INDEX

"FIXES ARE GREAT IN '98"

INTRODUCTION

Figure 1

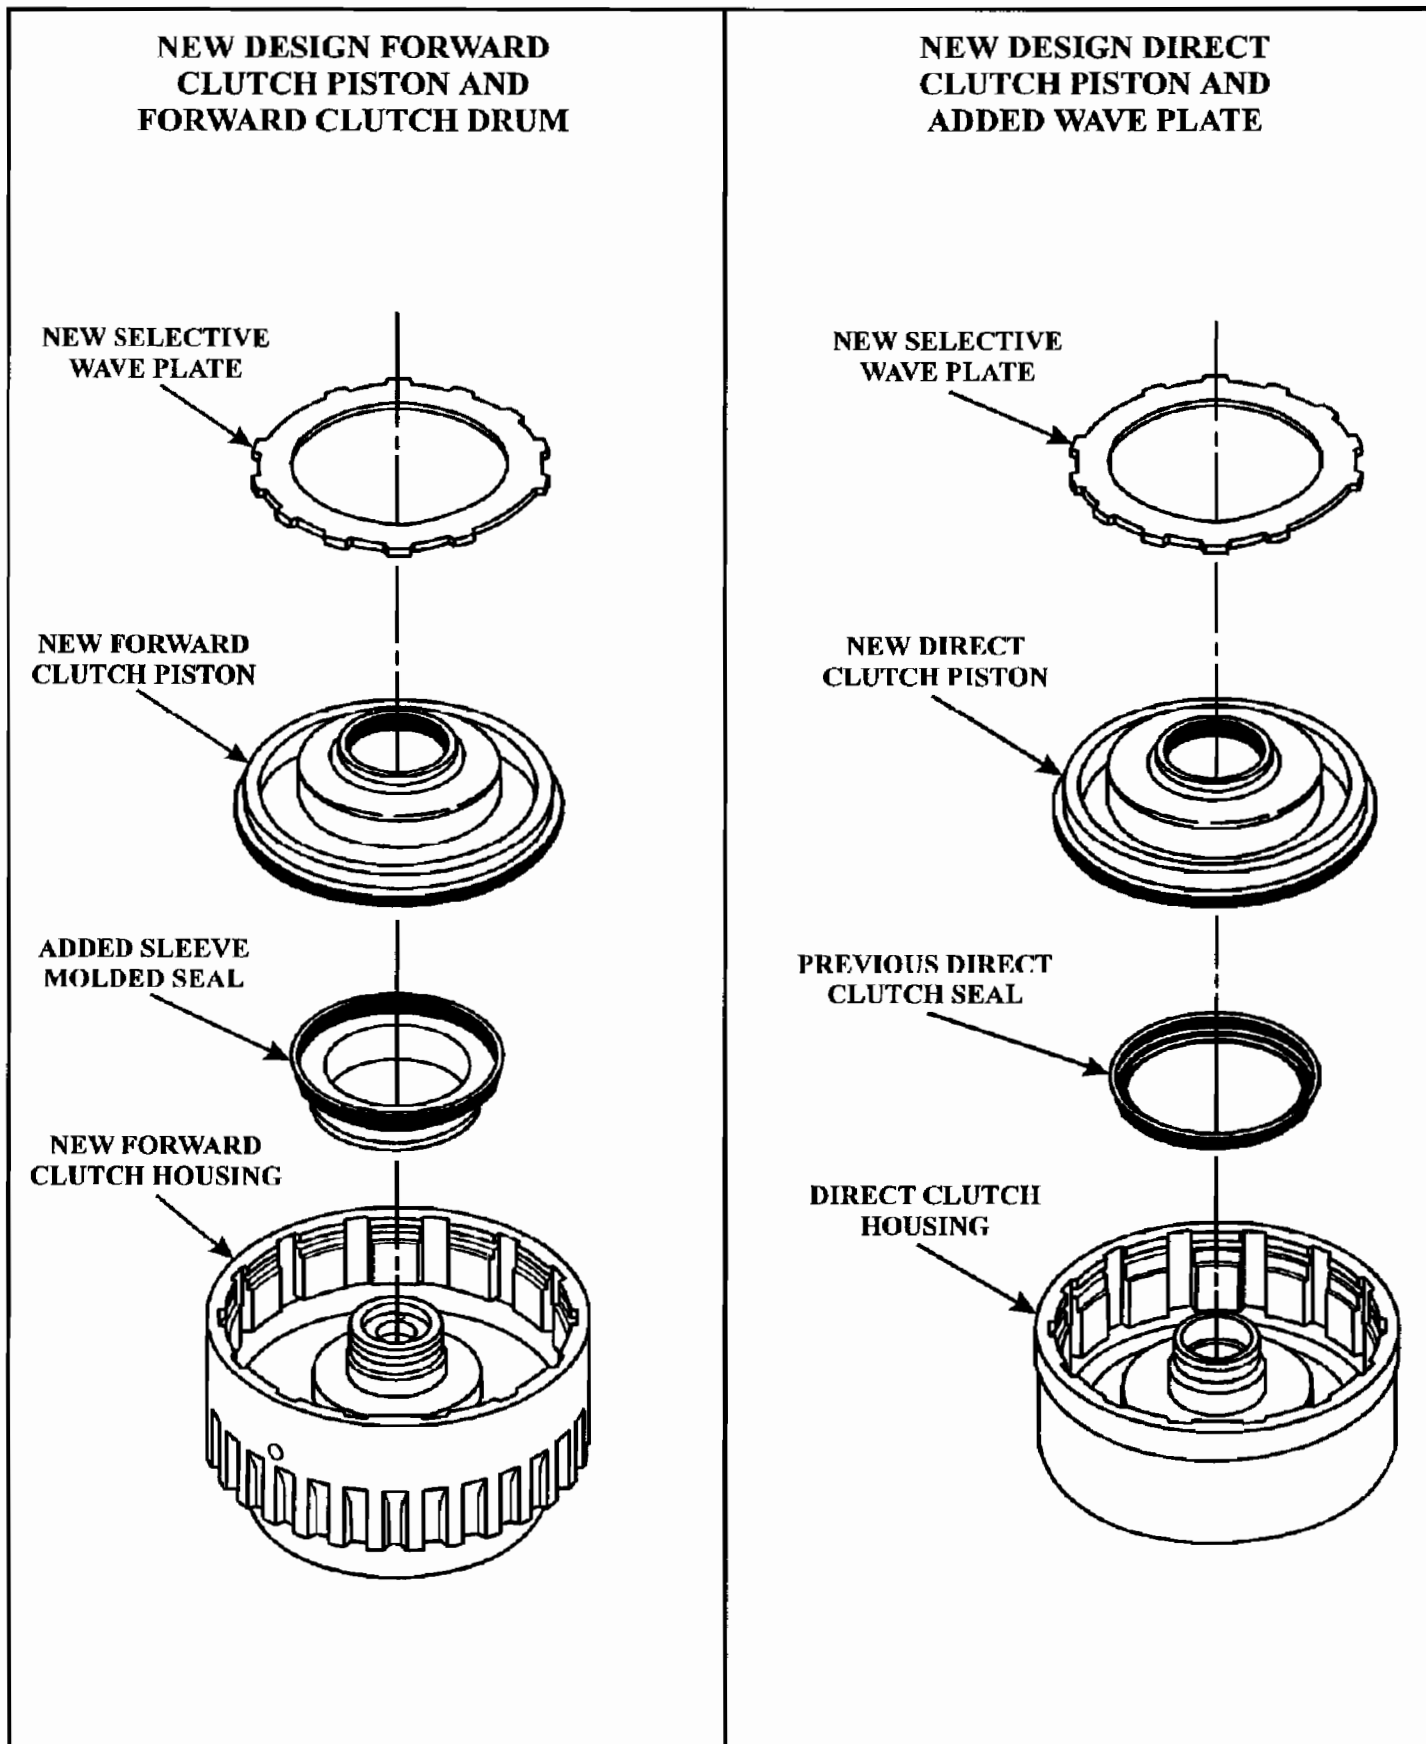
CHANGE: Beginning at the start of production for 1997, all THM 4L80-E transmissions were produced with new design forward and direct clutch piston assemblies that are stamped steel with molded rubber seals, as shown in Figure 1. The new design level forward clutch piston also changes the forward clutch housing, with the addition of a stamped steel forward clutch sleeve with a molded seal, that replaces previous lip seal, as shown in Figure 1.

- (1) FORWARD CLUTCH HOUSING - Has previous intermediate seal groove and intermediate lip seal eliminated, and is now machined to accept a new steel sleeve with a molded seal that replaces the previous lip seal located in the housing, as shown in Figure 1.

- (2) FORWARD CLUTCH PISTON - New design piston is stamped steel with molded seals to replace the previous cast aluminum piston, as shown in Figure 1.
- (3) FORWARD CLUTCH INTERMEDIATE LIP SEAL - Has been eliminated and replaced with a steel sleeve with the molded seal, as shown in Figure 1. (Currently not serviced separately)

- (4) DIRECT CLUTCH PISTON - New design piston is stamped steel with molded seals to replace the previous design cast aluminum piston, as shown in Figure 1.

Figure 1

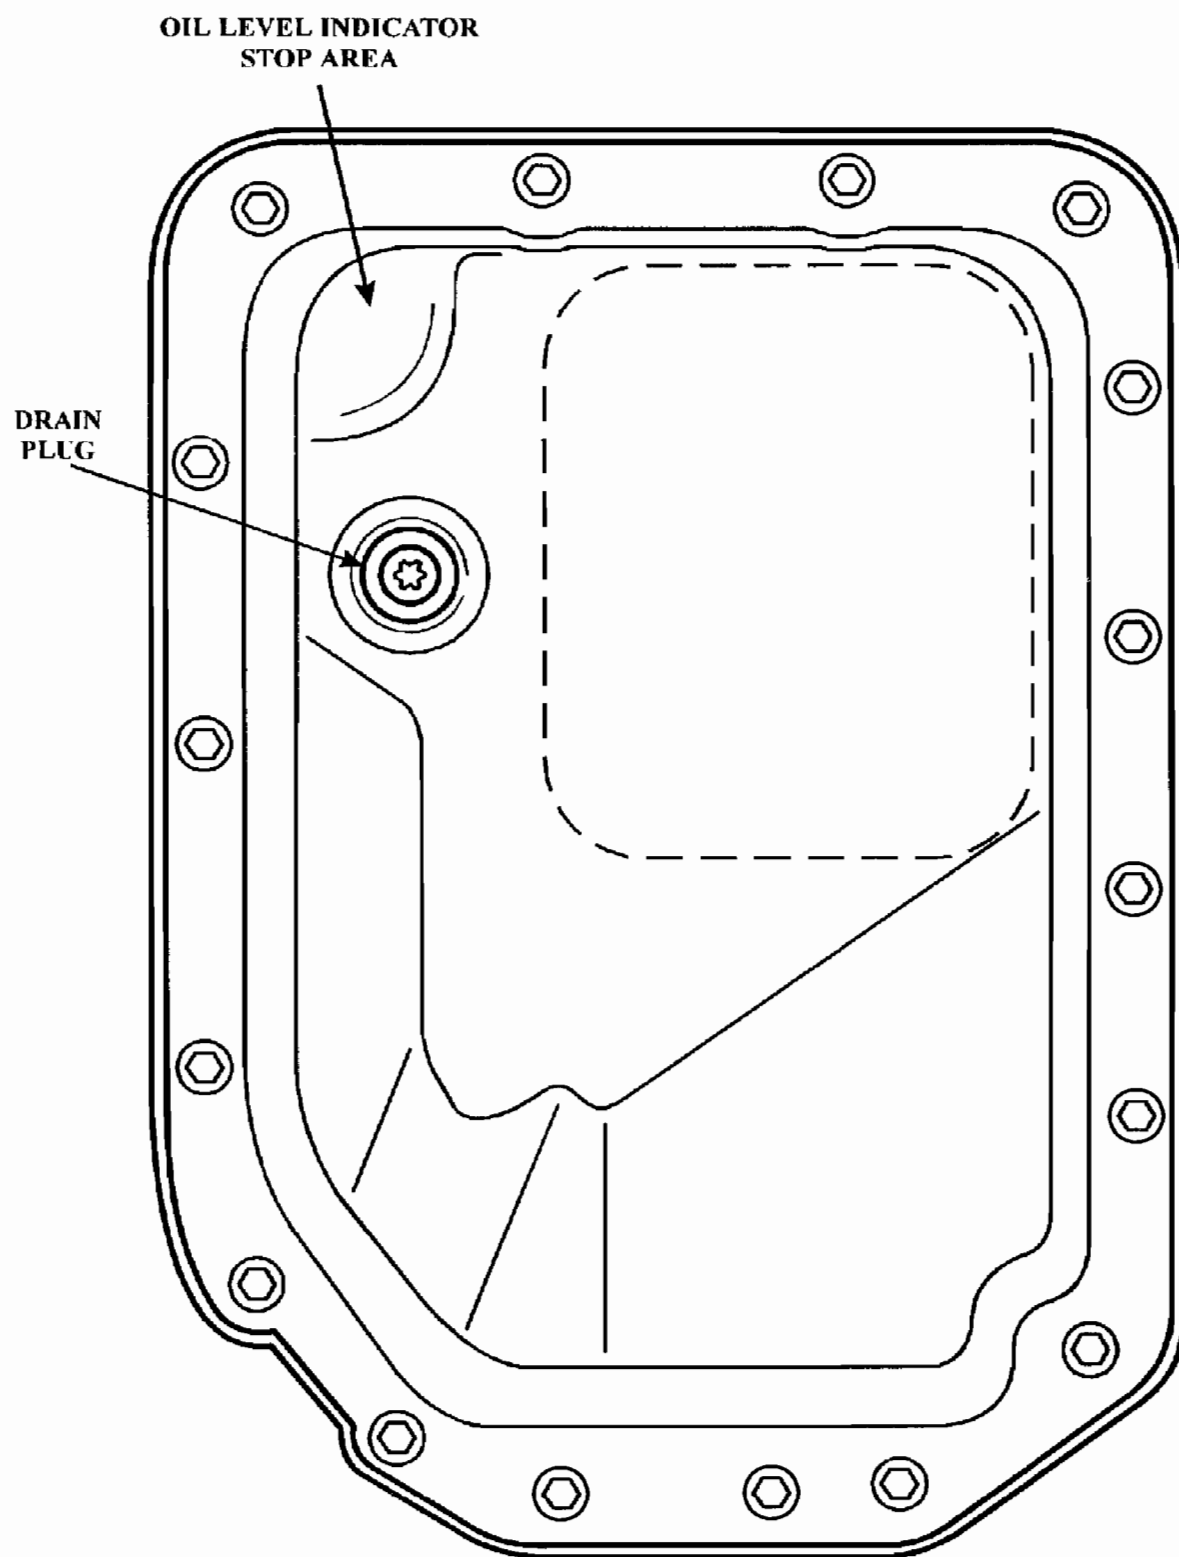
- (1) **BOTTOM PAN** - The new design oil pan has a contoured shape, is 7mm (.275") deeper than the previous model oil pan, and has an oil level indicator stop incorporated into the oil pan stamping (See Figure 1).
- (2) **OIL FILTER** - The new design oil filter has an inlet which extends deeper into the sump, and four raised "Dimples" to retain the oil filter in the filter neck seal. We have provided illustrations of the bottom of both oil filters in Figure 2, and illustrations of the oil filter profile in Figure 3, for purposes of identification.

Figure 1

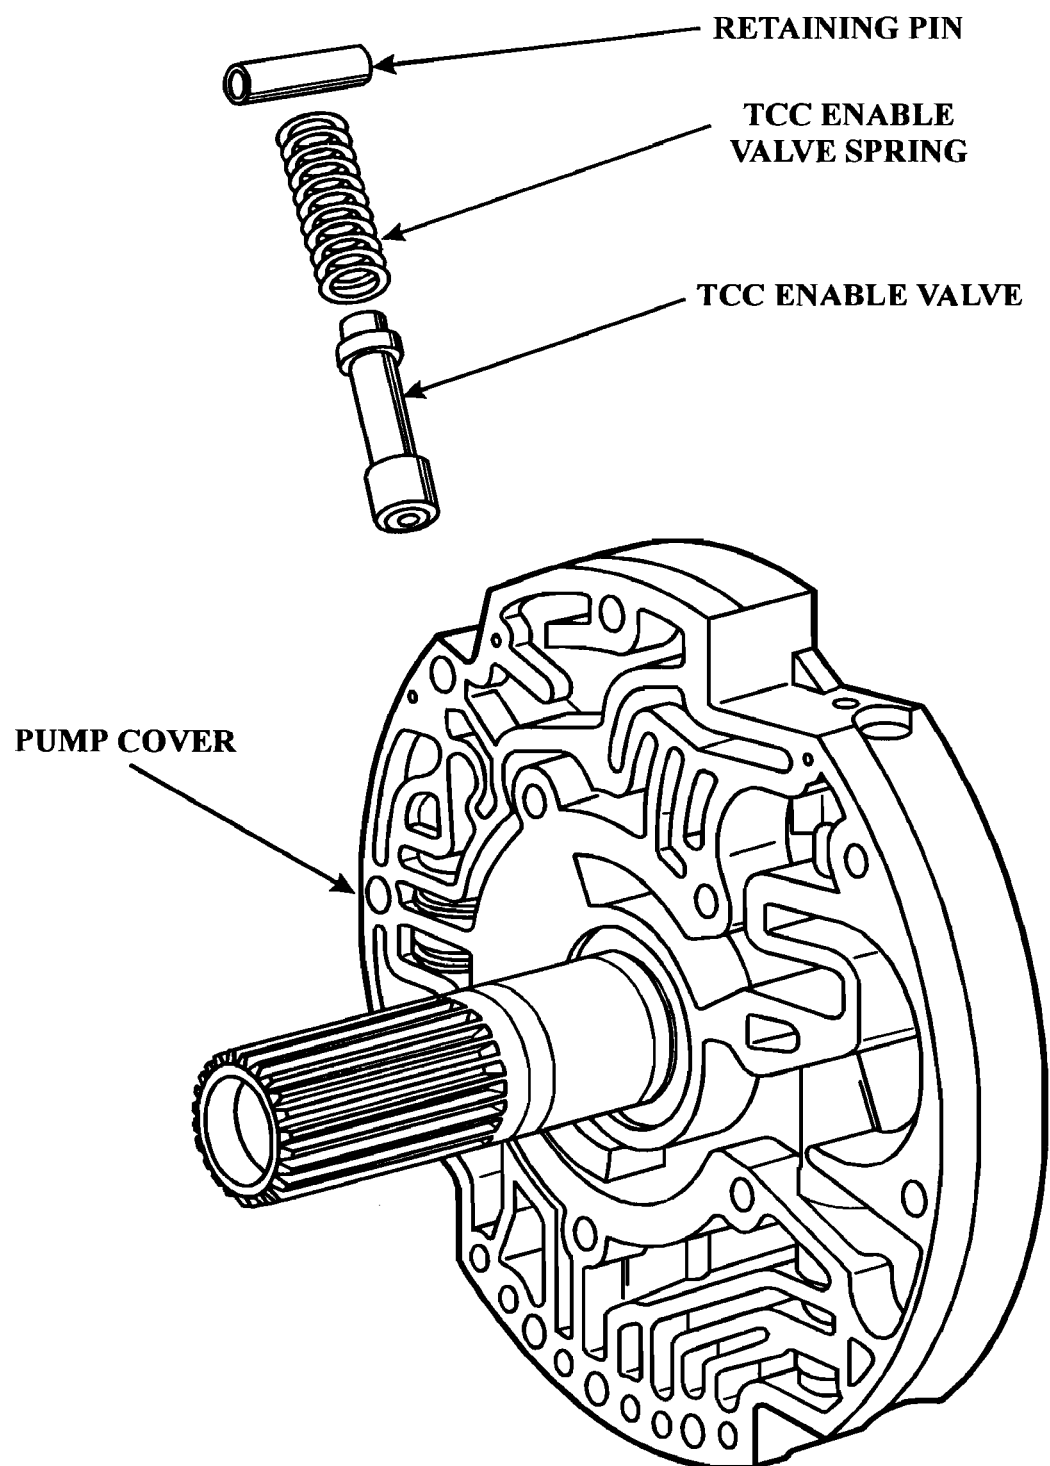
CAUSE: There are many electrical and mechanical reasons for these codes to be stored. After all of the electrical has been eliminated, the cause may be the TCC Enable Valve, in the pump cover assembly is in backwards.

CORRECTION: Remove the pump assembly and install the TCC Enable Valve in the direction that is shown in Figure 1, and ensure free movement after installation.

Figure 1

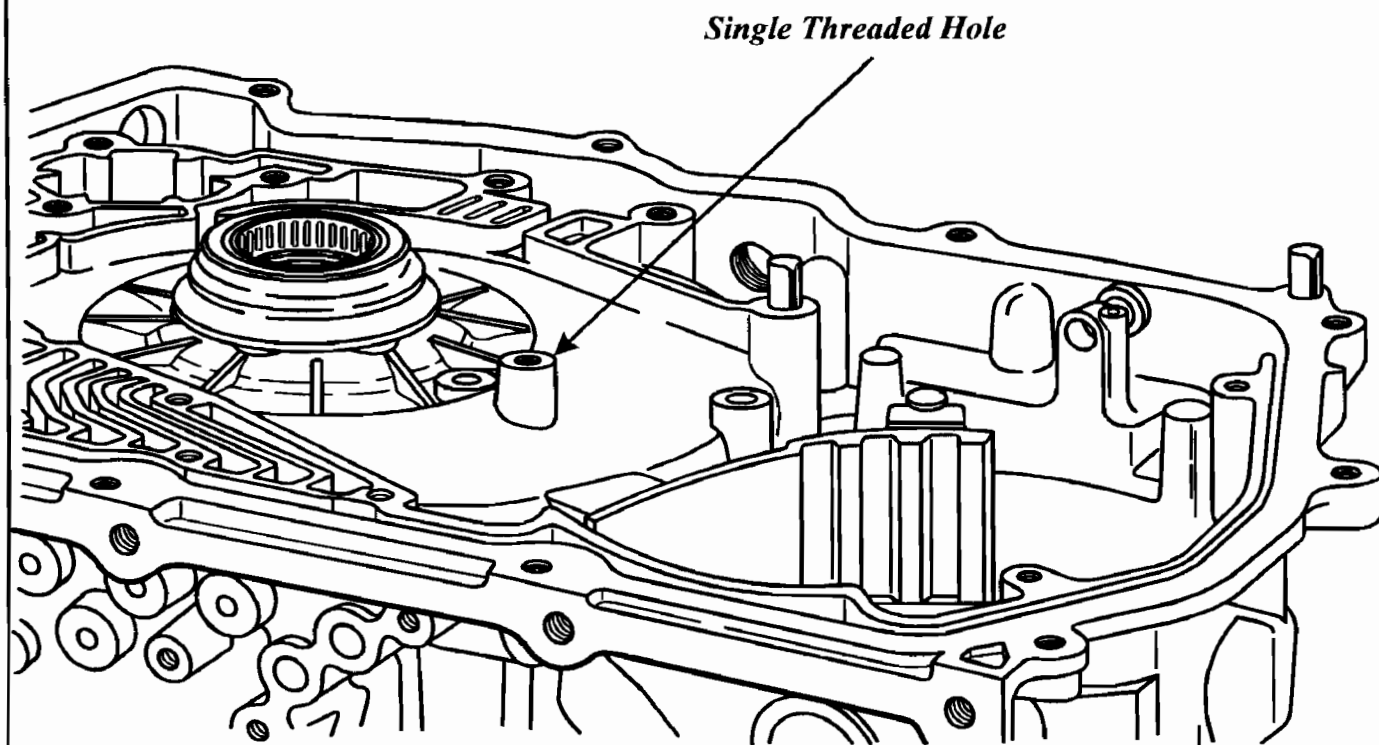
- (1) **TRANSAXLE CASE** - Added boss and the second threaded hole to the case in the area shown in Figure 2, to accommodate valve body bolt and channel plate changes for improved clamping. The previous design case, with the single boss and hole is shown in Figure 1.

Figure 3

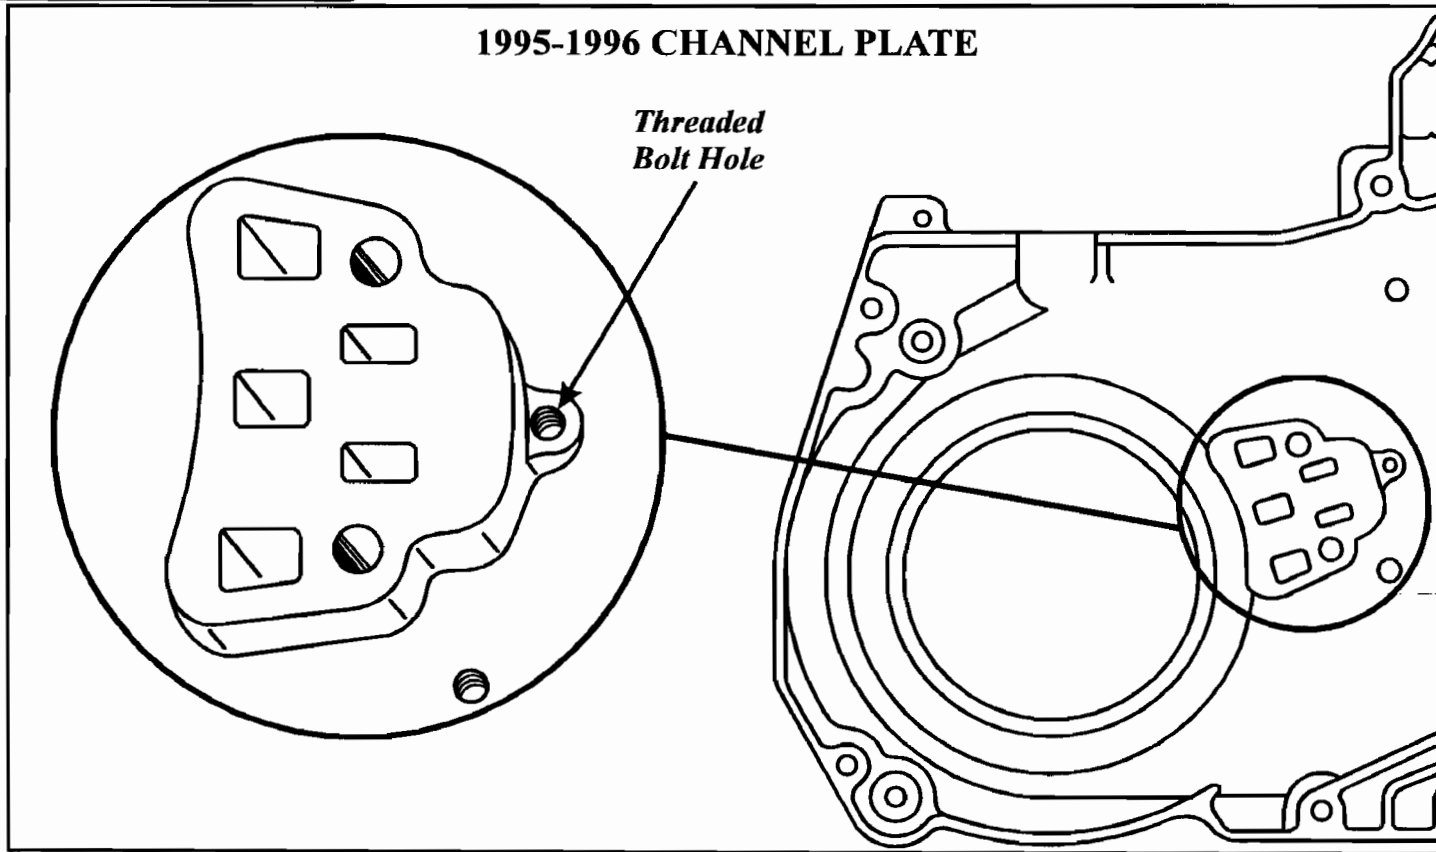
- (2) **CHANNEL PLATE** - New casting with an added boss, and one of the threaded holes in the channel plate changes to a non-threaded hole to accommodate the valve body bolt changes for improved clamping force. The previous design channel plate is shown in Figure 3, and the new design channel plate is shown in Figure 4.

Figure 5

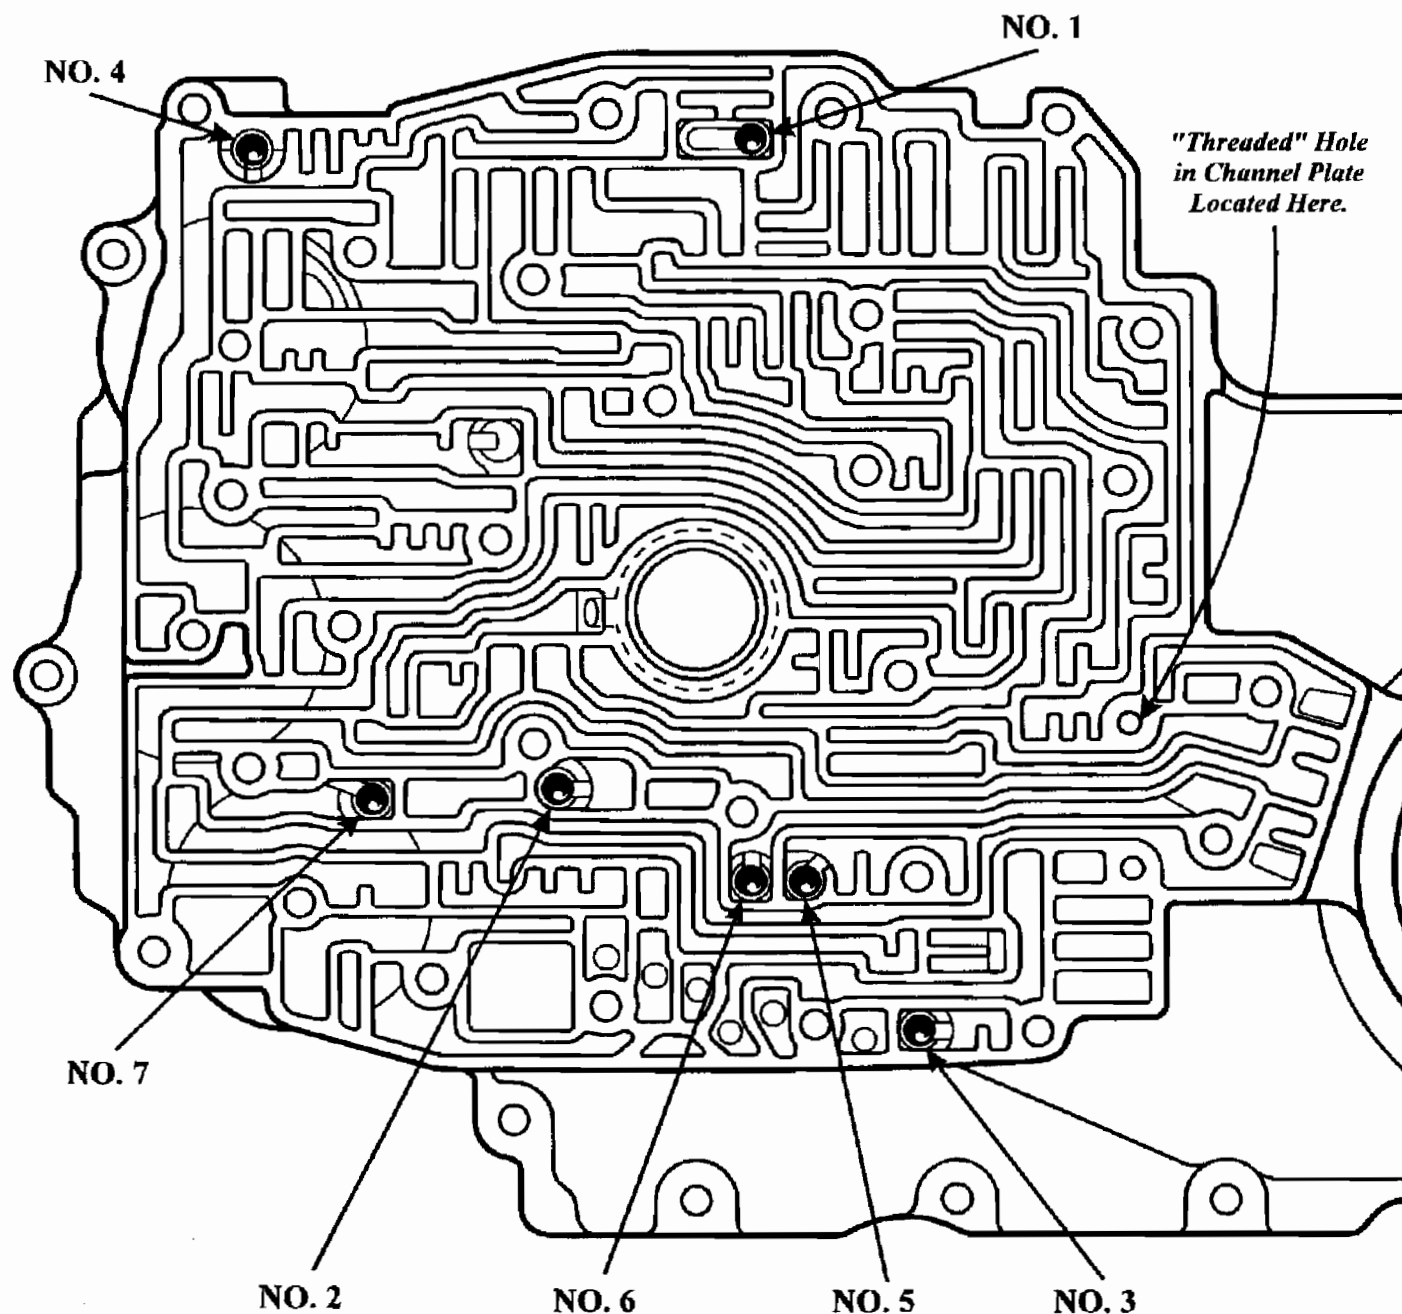
- (3) **CHECKBALL LOCATIONS** - The number 6 checkball moves from the direct clutch apply circuit, and into the 2-3 accumulator circuit. There were no changes in worm track configuration, however we also show the "Threaded" hole that changed to a "Non-Threaded" hole in the channel plate. Refer to Figure 5 for 1995-1996 checkball locations, and Figure 6 for the 1997-Up checkball locations.
